Product Change Notification

1. ECN #: 249463 **2. Date of Announcement**: May 01, 2015

• MTMM - 2MM TERMINAL STRIP

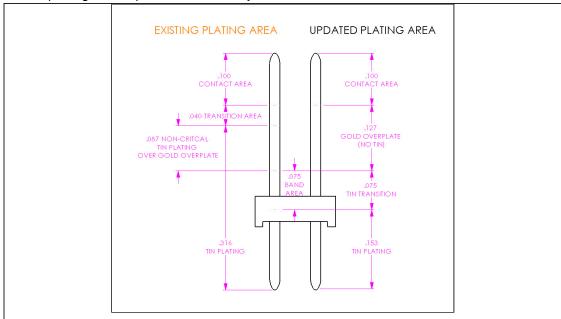
Tin plating was removed from non-critical areas on the post.

The tin plating on the post will be visually lower.

Double row connector shown. The visible tin plated area is lowered closer to the insulator.

Tin plating, specified in the non-critical area of the post, was deposited over gold overplating. The tin over gold condition could lead to discoloraiton in this area during wave solder processing.

• Form - The modification affects FORM only. The plating specifications of the functional mating contact area and solderable lead surfaces are not changed.
